Worcester County Fire Training Facility Vehicle Storage Project

Addendum 2

ADDENDUM #2**WORCESTER COUNTY VEHICLE STORAGE FACILITY****DBF #: 0085B049.A01****September 23, 2025**

Dwg.No.: 2 (C-101)

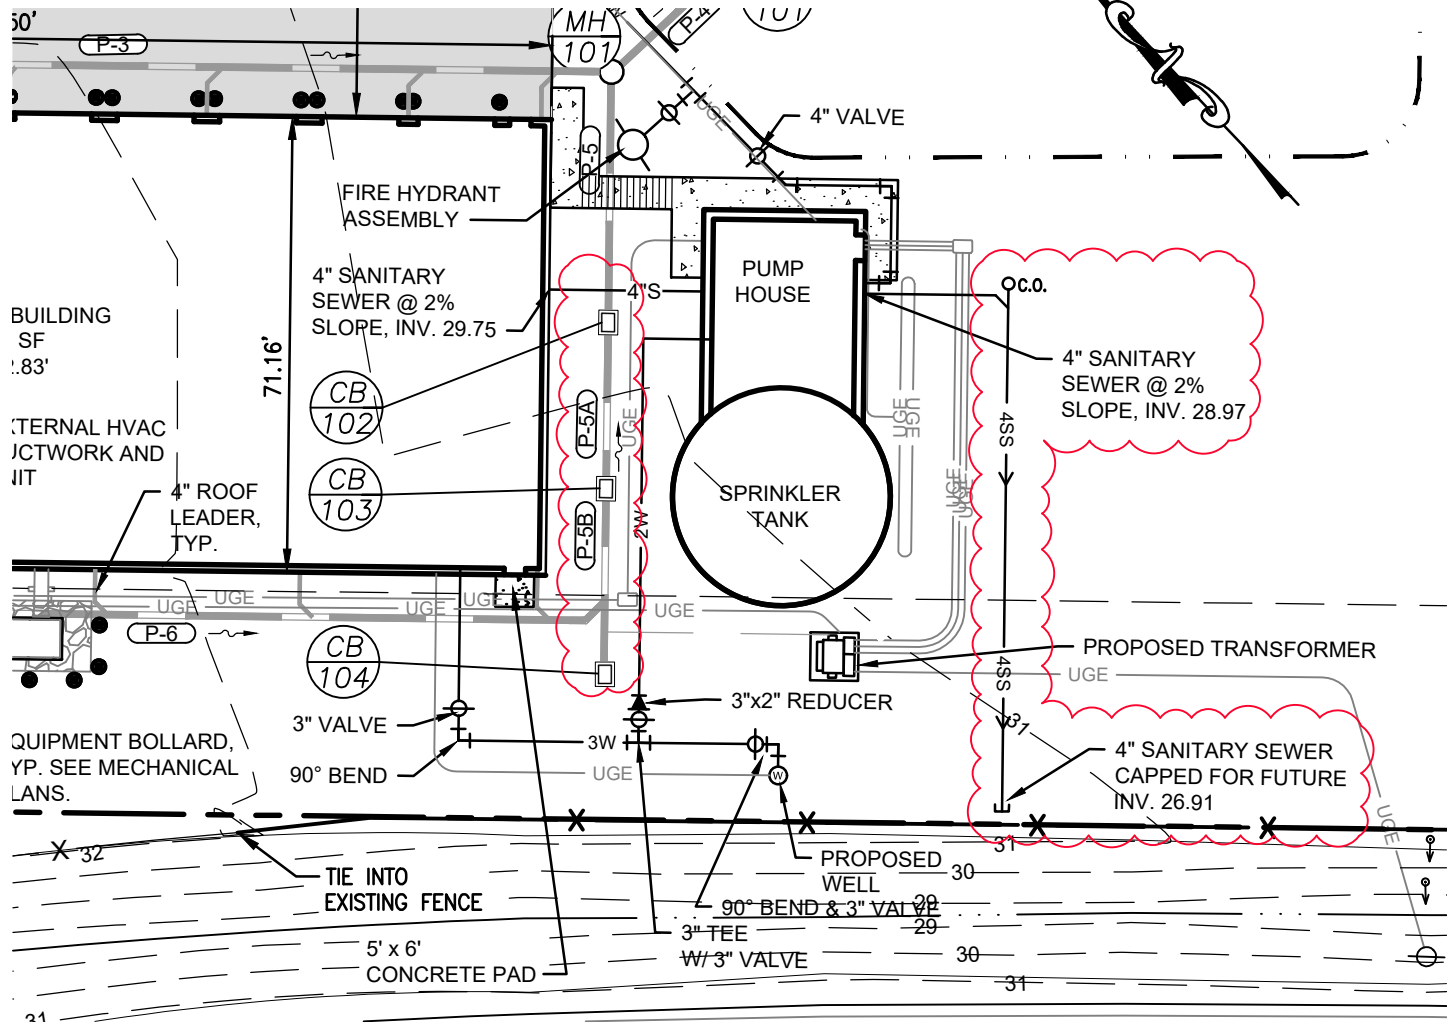
23. Revised Bid Form is attached.
24. Refer to attached Drawing 2 (C-101) for information regarding new pavement at the old training tower location and pavement extension at the north side of the Vehicle Storage building.

Dwg.No.: 3 (C-101)

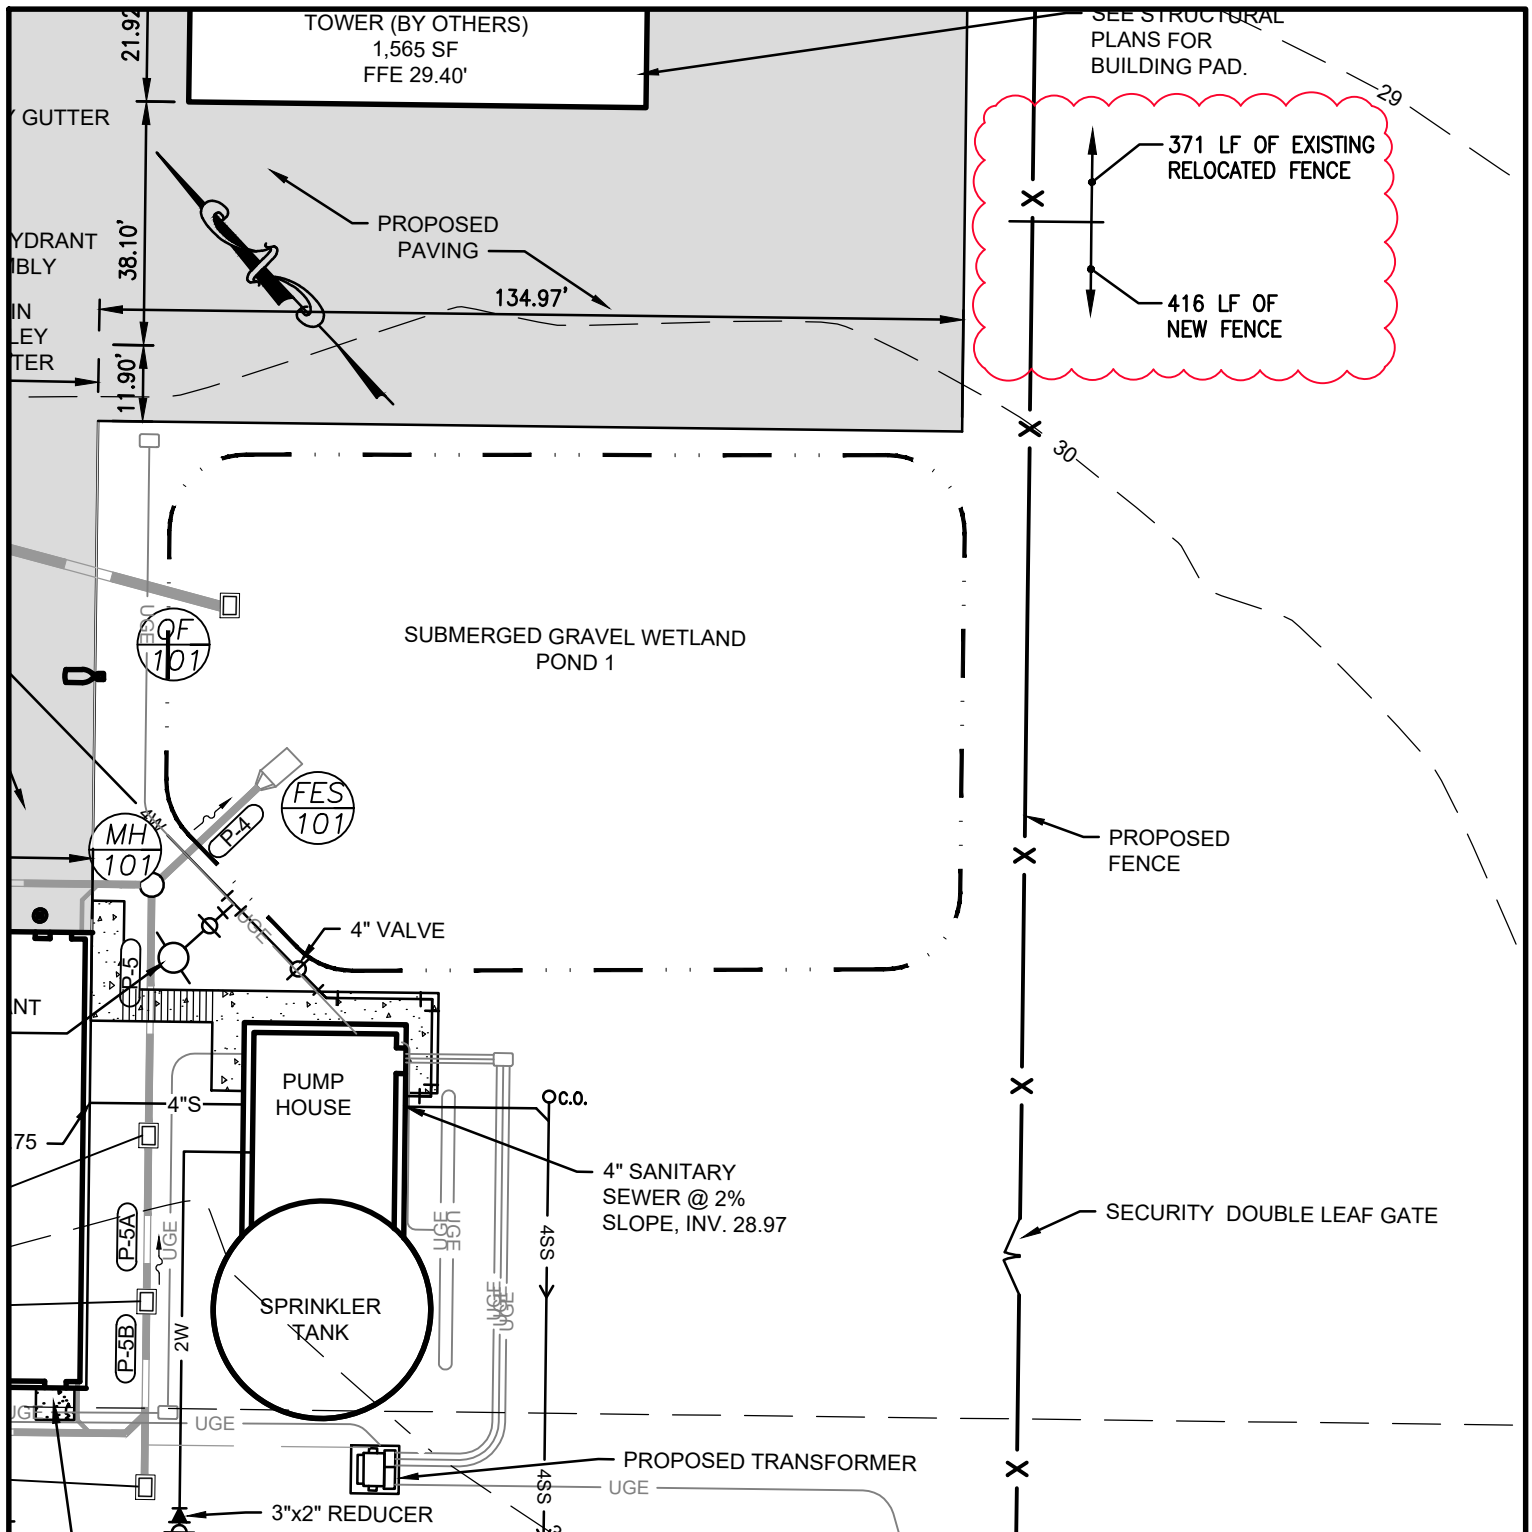
27. Refer to attached Drawing 6 (C-102) for information regarding the site valley gutter detail.
28. Refer to attached Drawing 3 (C-101) for locations of yard inlets between the Vehicle Storage building and the Pump House.

Dwg.No.: 4 (C-101)

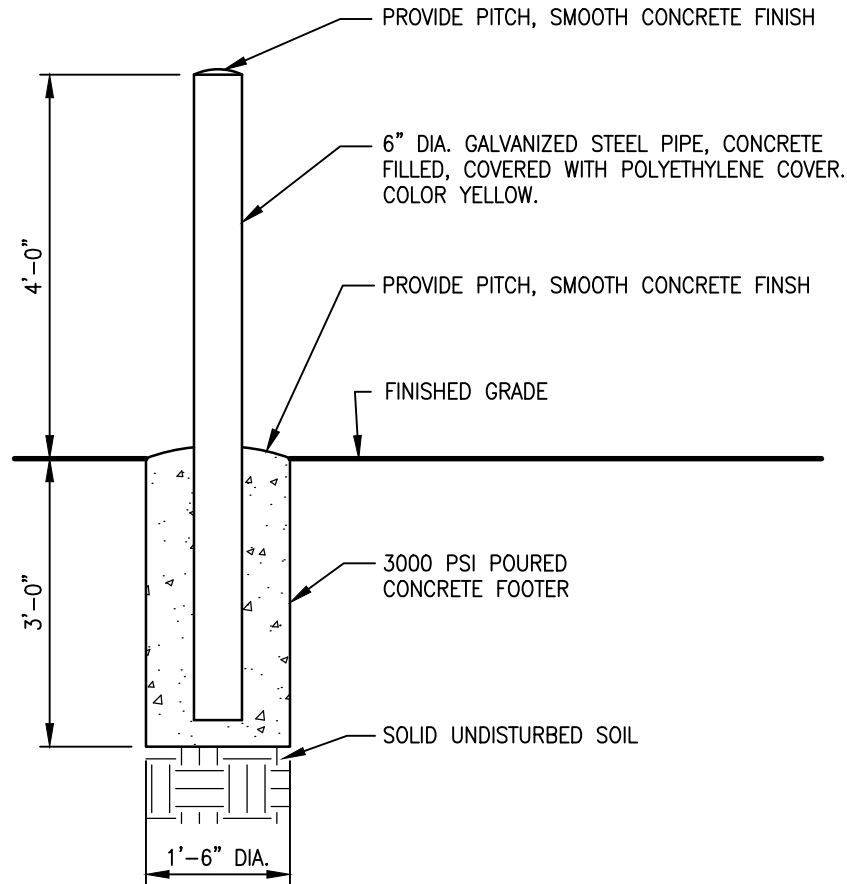
29. Refer to attached Drawing 4 (C-101) for information regarding new and relocated existing fence. The new fence will have barbed wire at the top to match the existing. See attached Drawing 13 (C-102) and 14 (C-102).

Dwg.No.: 8 (L-101)

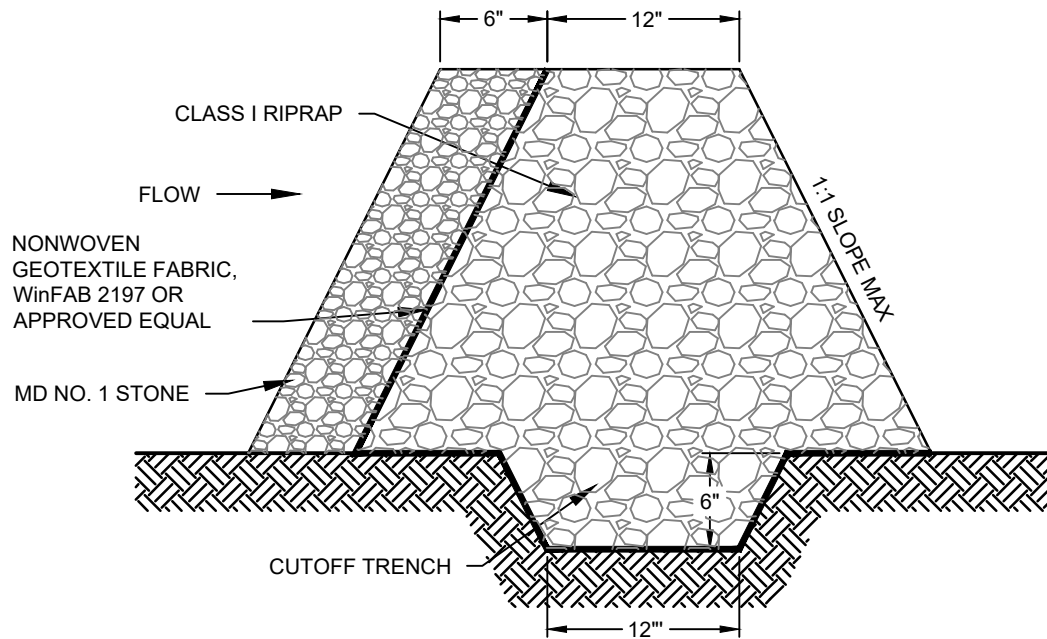
32. Refer to attached Drawing 8 (L-101) for the revised plant schedule.
33. Refer to attached Drawing 9 (C-303) for the stone berm forebay detail (Gabon Wall detail).

SIGN DETAIL

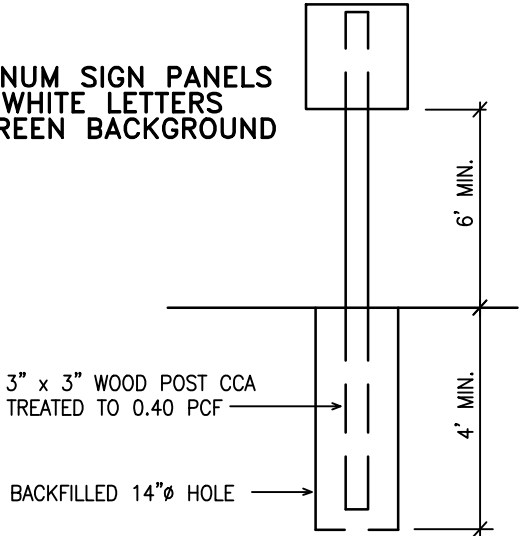
34. Refer to attached Drawing 10 (FC-101) and 11 (FC-101) for locations of six forest retention area signs and sign detail.

Date:	09.22.2025
Scale:	1"=1'
Dwn.By:	JKB
Proj.No.:	0085B49.A01
ADDENDUM 2	
Dwg.No.:	12 (C-101)

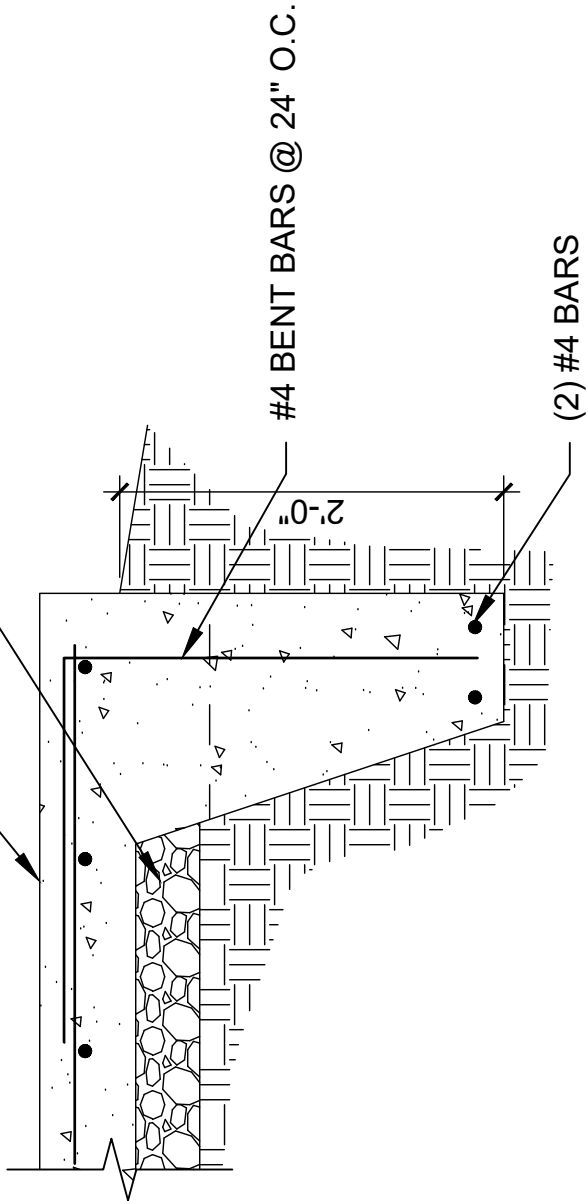
26. The concrete pad for the ERV unit is 30' x 12'. This will be confirmed. Attached is Drawing 12 (C-101) showing the equipment pad detail for the ERV.

SECURITY DOUBLE LEAF CHAIN LINK GATE DETAIL NOT TO SCALE

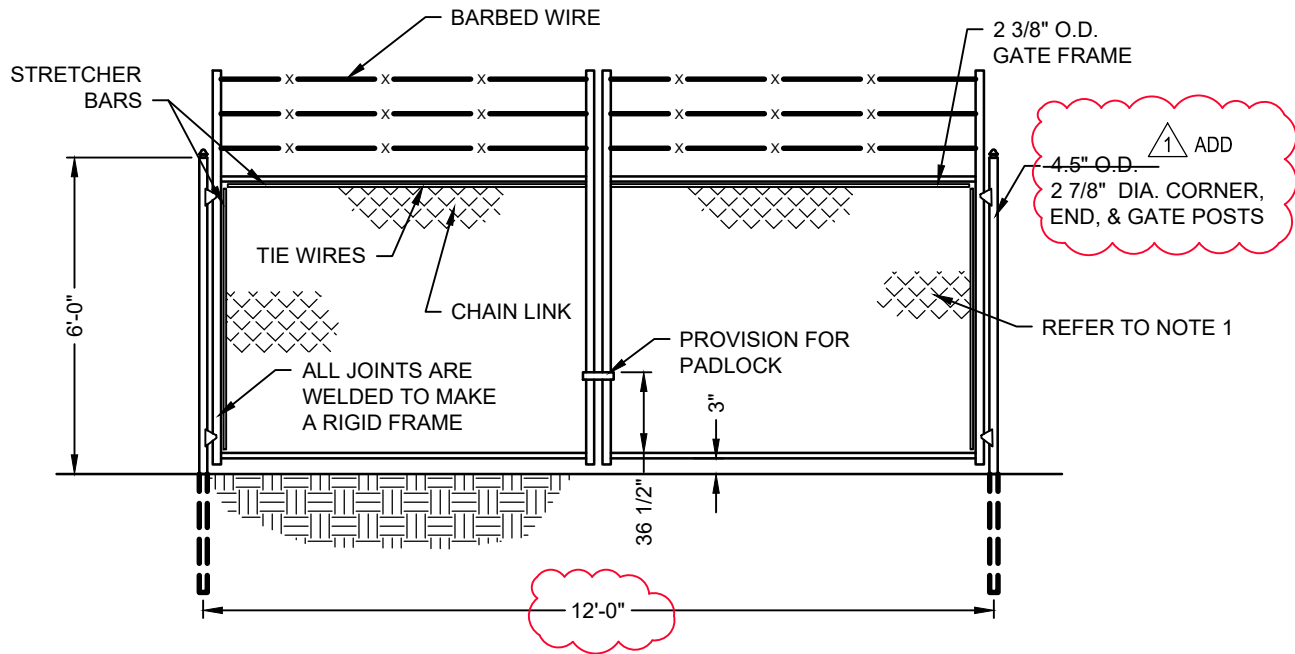
30. The Double Leaf security gate shown on Sheet C-102 will be 12' wide.
31. Refer to attached Drawing 7 (C-302) for revised schedules that include the three (3) new yard inlets.

STORAGE BAY

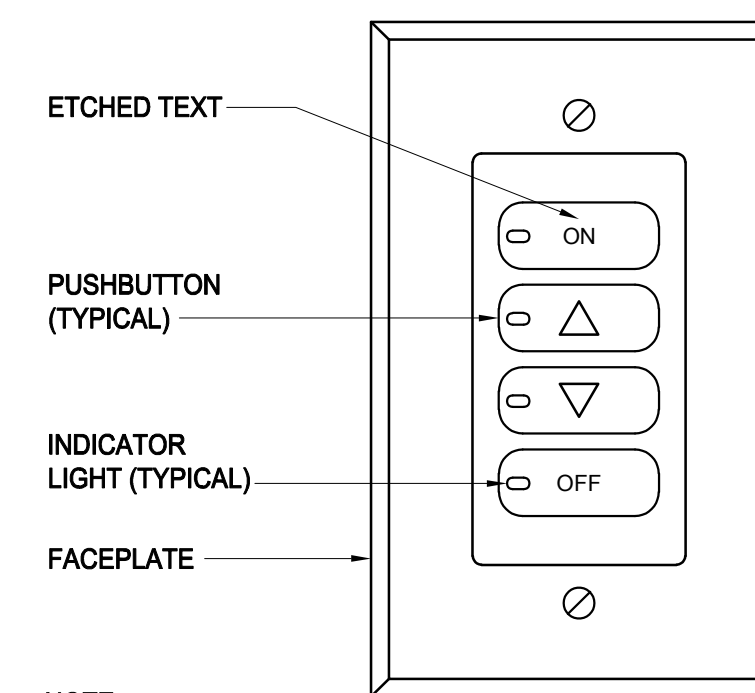
10. Revised Sheet E-401 is attached which shows the revised sequence of operations for lighting control.
11. With regard to the security gate noted on Sheet C-102, the gate post OD is 2.5", not the 4.5" noted.
